Access Compliance Report

Public Rights-of-Way

(Curb Ramps)

Intersection ID: 47469	Main Street: KALISPELL_LN	Cross Street: ELENDIL_LN	Location: NE
ADA ID: 0A06152F51D1	Ramp Type: BlendTrans1	Initial Pass/Fail: Fail	Overall Compliance: No
		Severity Score: 10

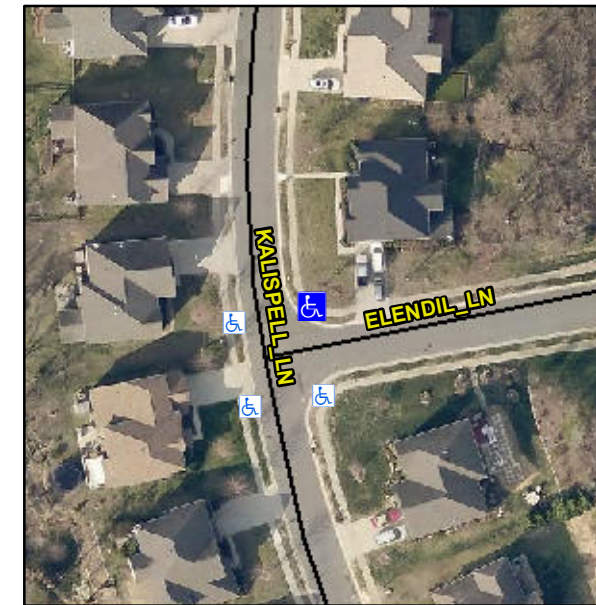
Not Found, R304.5.1, R304.5.3

Compliance	Description	Data	Compliance	Description	Data
N/A	Ramp Length (in)	46.5	Yes	BlendTrans Slope (%)	0.9
No	Ramp Width (in)	47.0	No	BlendTrans XSlope (%)	3.1
N/A	Flare Type LT	N/A	N/A	Flare Type RT	N/A
N/A	Flare Slope LT (%)	N/A	N/A	Flare Slope RT (%)	N/A
N/A	Flare Traversable LT?	N/A	N/A	Flare Traversable RT?	N/A
N/A	Landing Length (in)	N/A	N/A	DWS Provided?	N/A
N/A	Landing Width (in)	N/A	N/A	DWS Contrast?	N/A
N/A	Landing Slope (%)	N/A	N/A	DWS Length (in)	N/A
N/A	Landing X Slope (%)	N/A	N/A	DWS Full Width?	N/A
N/A	Landing Curb? (Y/N)	N/A	N/A	DWS Offset (in)	N/A
N/A	Shared Landing?	N/A			
N/A	Gutter Ponding?	N/A	N/A	Gutter Slope (%)	N/A
N/A	Gutter Lip Ht (in)	N/A	N/A	Gutter X Slope (%)	N/A
N/A	Painted X Walk1?	No	N/A	Painted X Walk2?	No
	X Walk 1 Direction	To W		X Walk 2 Direction	To S
	X Walk 1 Width (in)	N/A		X Walk 2 Width (in)	N/A
	X Walk 1 Slope (%)	0.7		X Walk 2 Slope (%)	5.4
	X Walk 1 X Slope (%)	5.4		X Walk 2 X Slope (%)	0.7

N/A	Ramp inside XWalk1?	N/A	N/A	Ramp inside XWalk2?	N/A
	Road Slope (%)	2.5		Clear Space?	N/A
	Road X Slope (%)	6.8	N/A	Clear Space to XWalk (in)	N/A
N/A	Any Obstructions?	N/A	N/A	Storm Grate/Utility Hazard?	N/A
	Obstruction Type			Storm Grate/Utility Type	
		N/A			N/A
			Yes	Surface Condition? (G/P)	Good
			No	Curb Slope (%)	19.5

Remove & Replace Curb Ramp With Two New Directional Ramps or Equivalent.
